# Comment #122 on Draft 1.1

IEEE 802.3bp - Interim Meeting - January 2015

# Comment #122

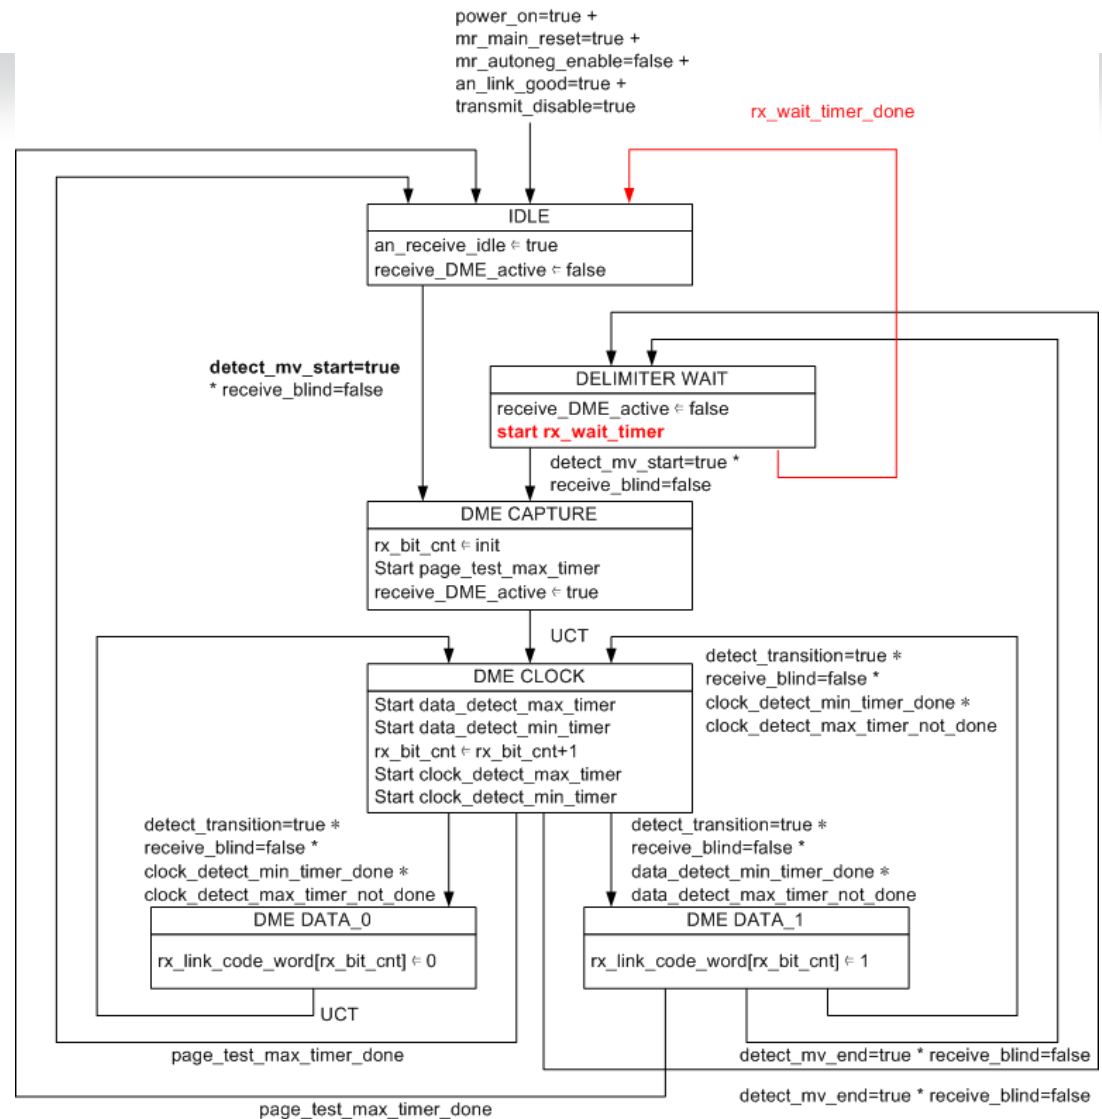
- There is a lockup condition in state DELIMITER WAIT.
- If the link partner stops transmitting there is no path back to the IDLE state which triggers TRANSMIT\_DISABLE

- Add a transition to IDLE. Clause 73 had this transition. See Fig 73-10
- Take this path after a sufficient timeout  $rx\_wait\_timer = 100$  to  $105\mu s$
